Architect's Supplemental Instructions

Architect's ASI No: 033

Webster University

Description: ASI – 033

ENLARGED PLANS-LEVEL
01

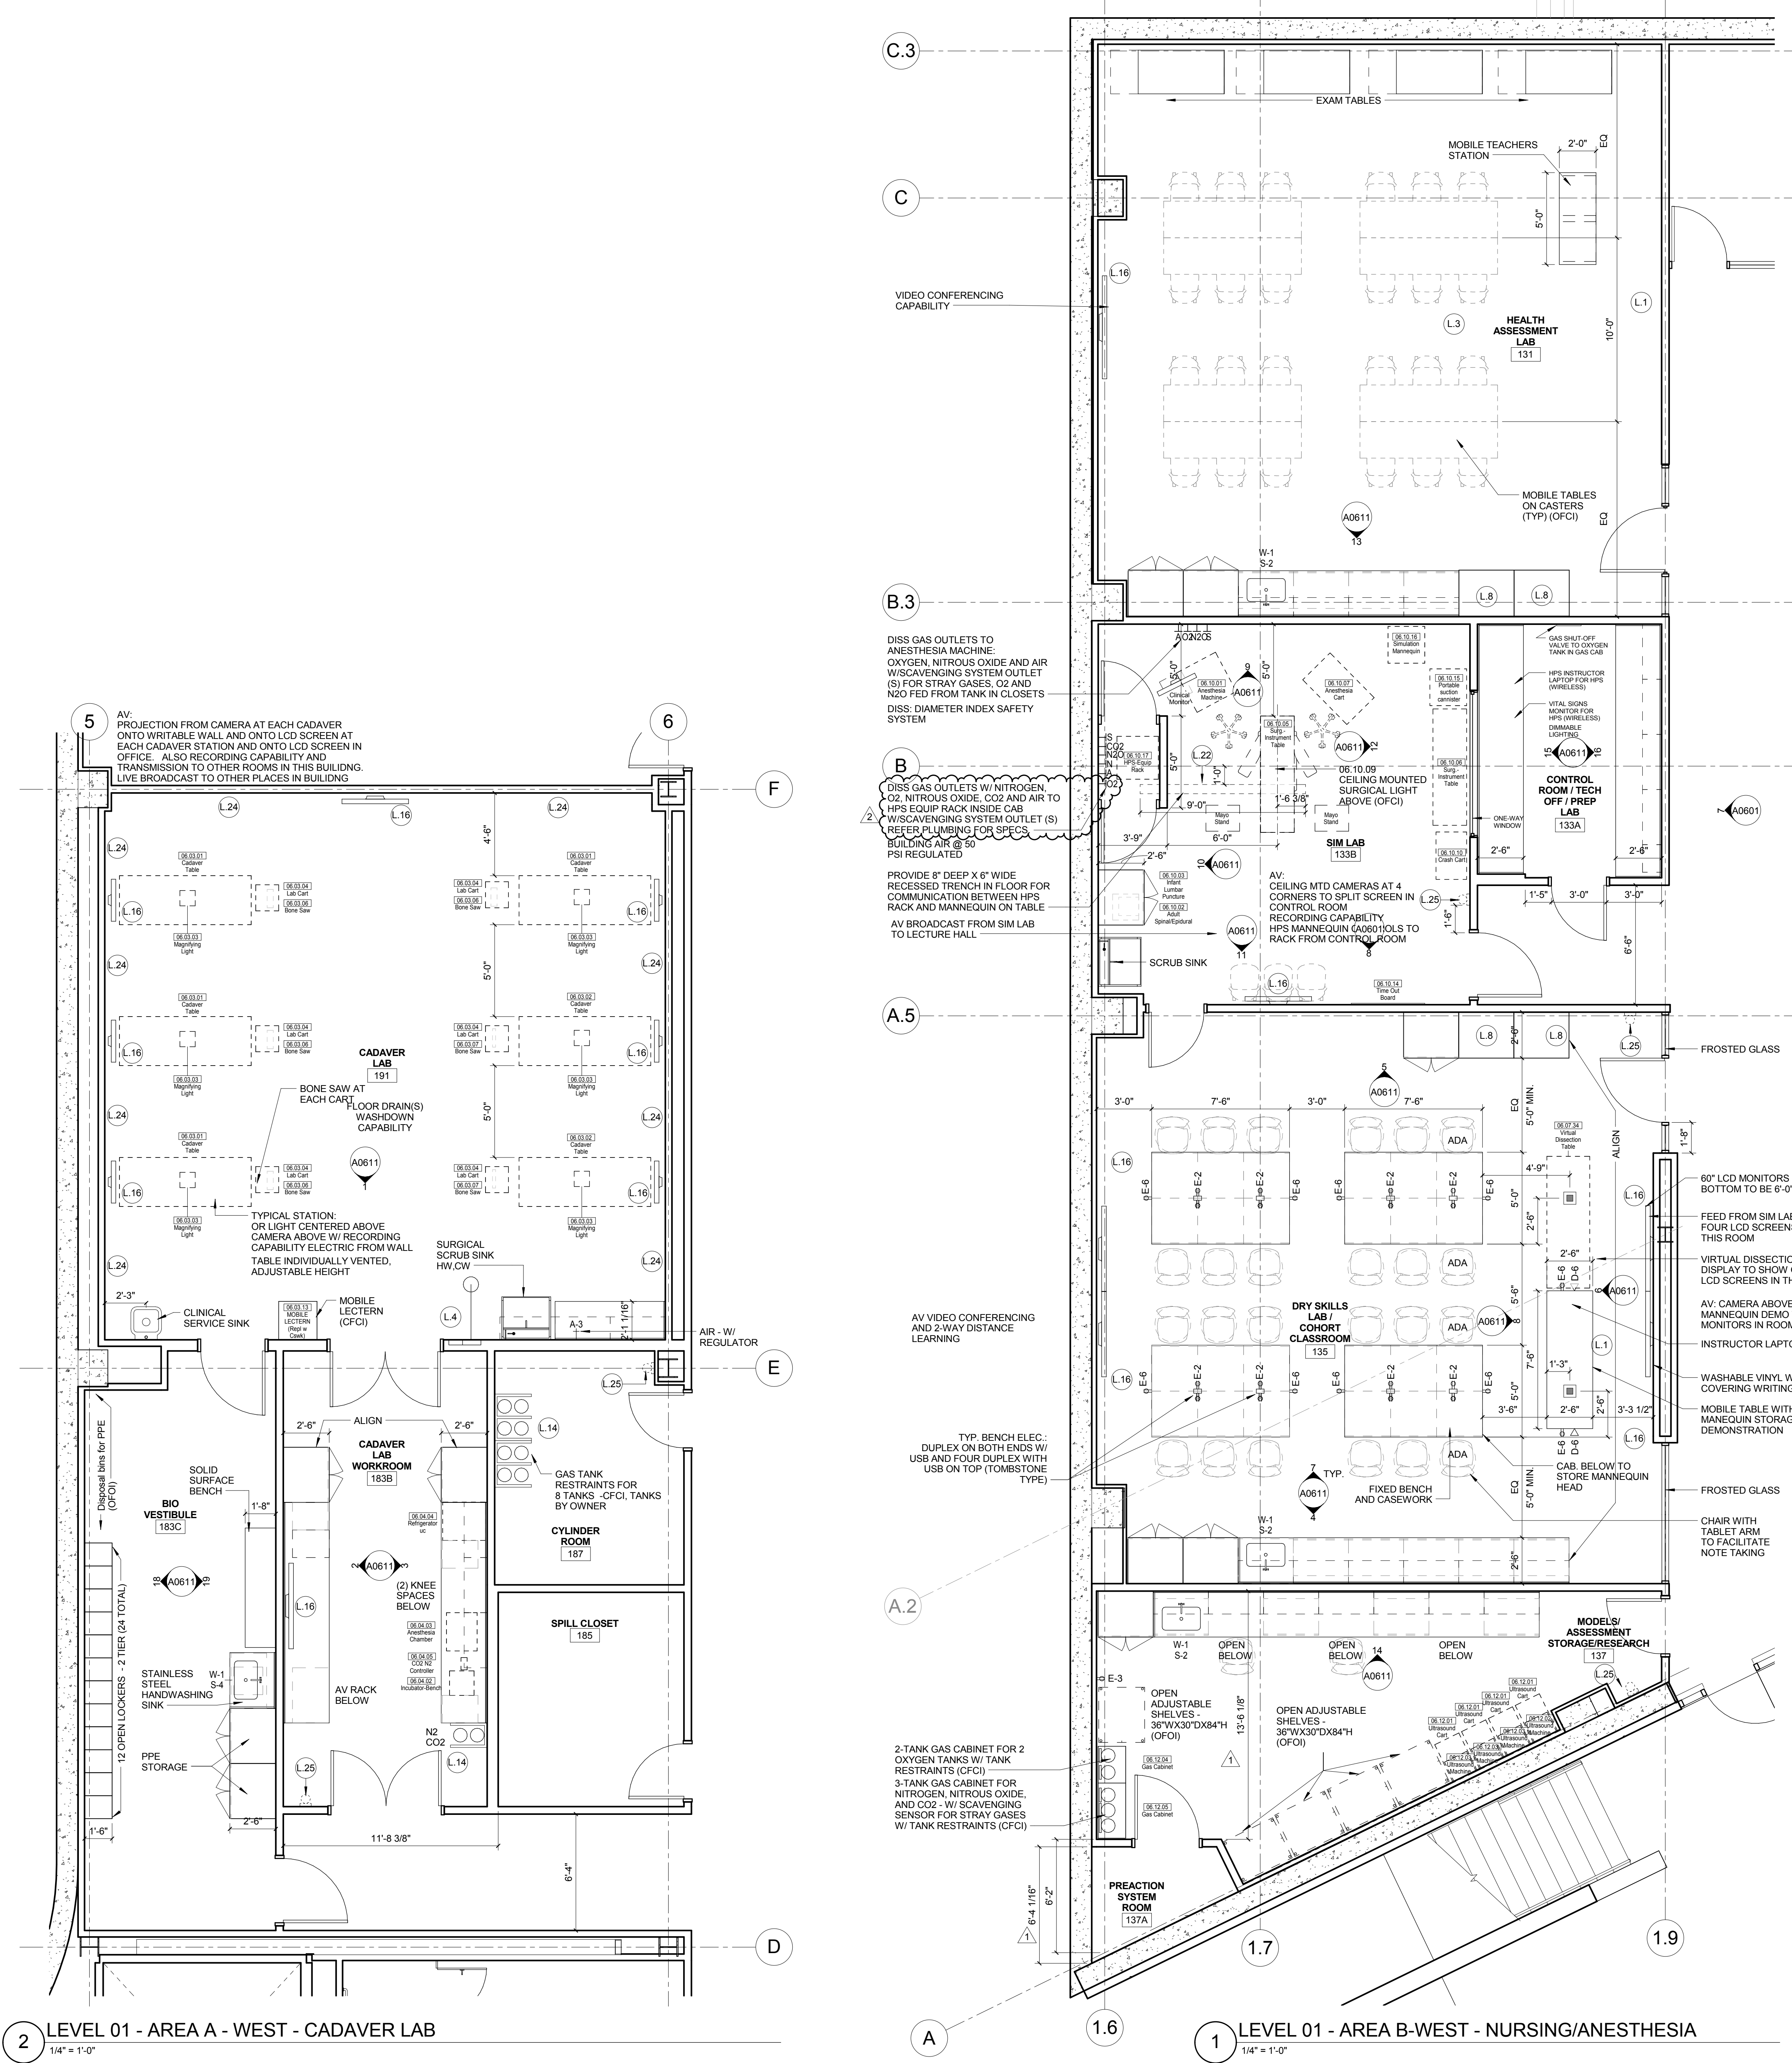
A0201: Oxygen DISS gas outlet added for HPS-Equip Rack (06.10.17) in the closet within SIM LAB (133B) per Webster University's direction.
